From: [Kathleen Menke](#)
To: [Alekk Fullerton](#)
Cc: [Tom Morphet](#); [Andrew Conrad](#)
Subject: Lutak Dock
Date: Sunday, February 11, 2024 11:45:25 AM

LUTAK DOCK DESIGN NEEDS 2ND LOOK

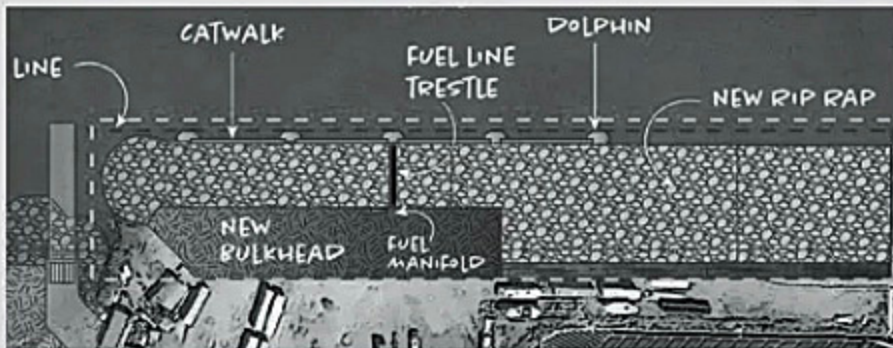
IN TURNAGAIN'S ESTIMATES, MAINTENANCE COSTS EXCEED THE LUTAK DOCK'S NET INCOME

Turnagain's design uses 3000 tons, or 6 million pounds of steel, which is equivalent to 2,500 cars or 26 statues of liberty! (US Army CMA, 2003)

Steel in saltwater is corrosion-prone. Protective coatings are toxic and expensive to maintain. The best way to reduce maintenance costs is to reduce the amount of steel in the water.

Excess maintenance costs get passed to borough residents, whether through higher taxes or higher freight costs.

ORIGINAL DESIGN -- IT'S NOT TOO LATE

Let's go back to the original design - with some modifications. R&M's 2021 design was already approved by MARAD. The original design had a minimum of steel in saltwater-- which would save residents money. If the original design were modified to not accommodate Handymax ships, **this design could be safer, cleaner, faster, cheaper, less controversial, and easier to permit.** Demolishing the old cells, adding rock slopes (rip rap), accommodating fuel shipments, and adding moderately-sized dolphins and a catwalk would serve current users. Plus, it's a lasting solution and not yet out of reach. **But the assembly must act fast.**
